### 77.3.3.2 Variables

Figure 77-22—Discovery Processing ONU Registration state diagram

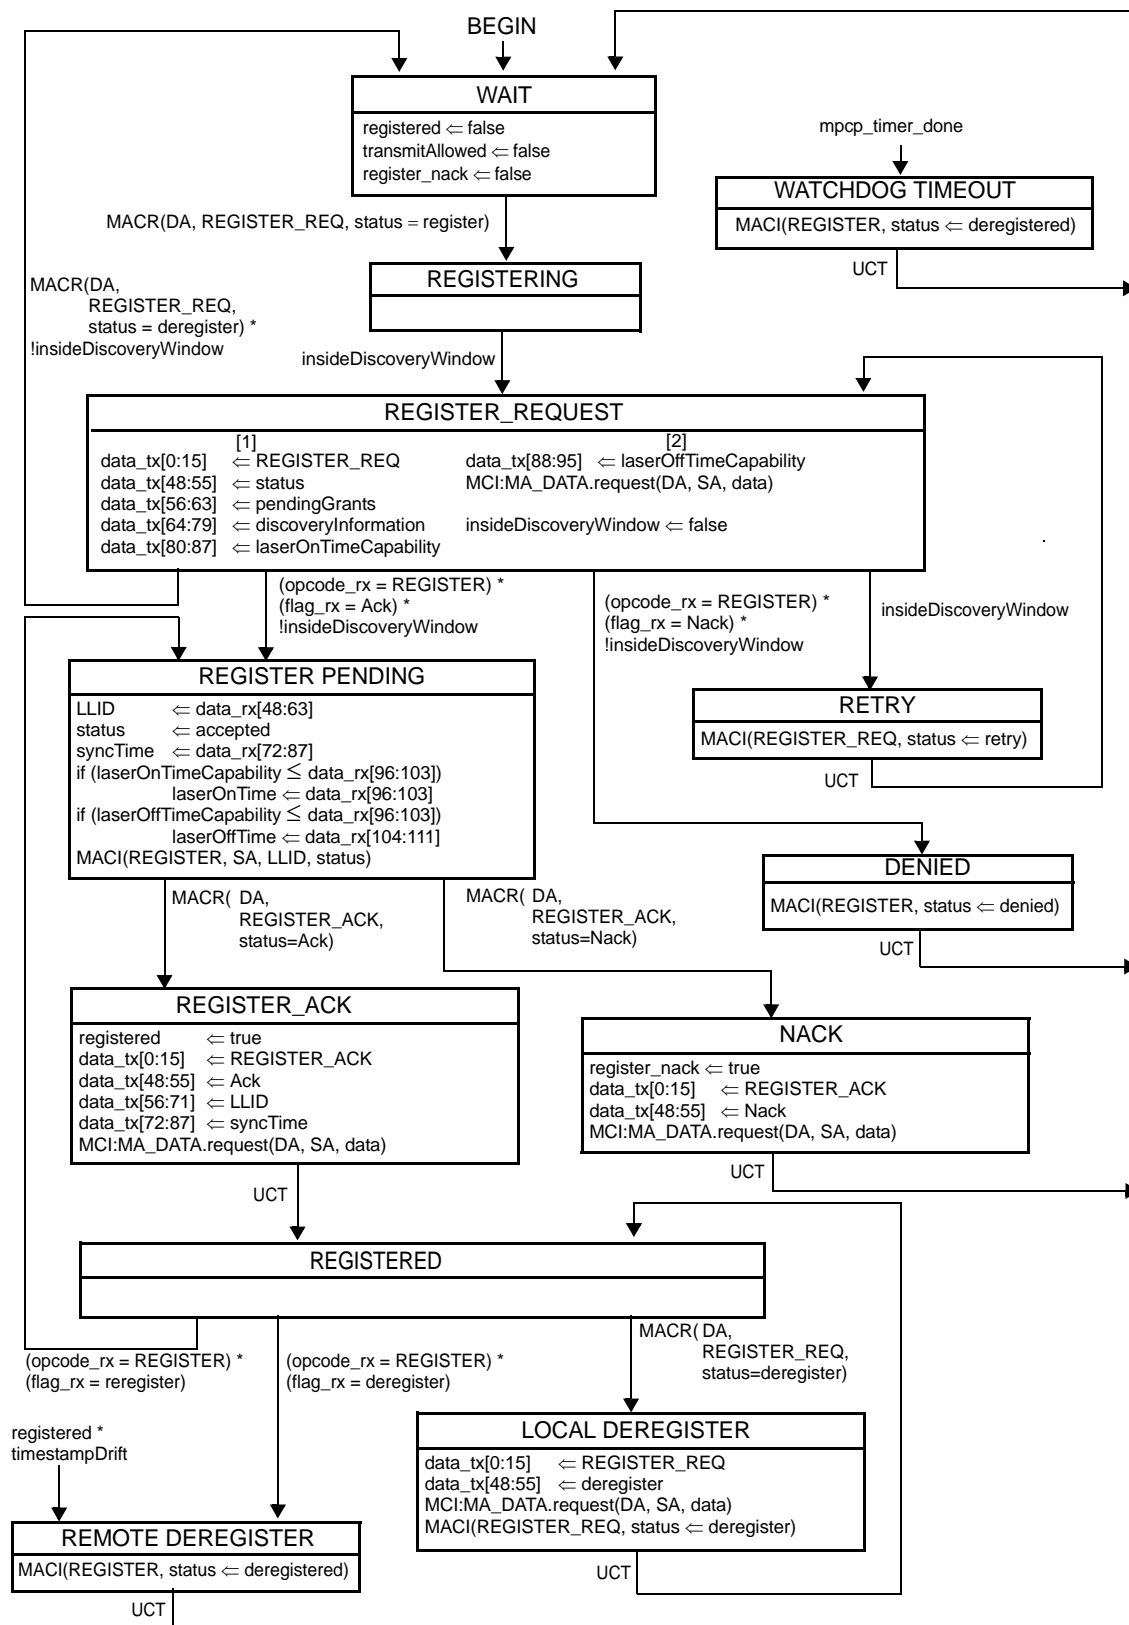
This variable indicates whether registration was denied by ONU DBA client. It is set to true in NACK state on @@Figure 77-22@@ and set to false otherwise.
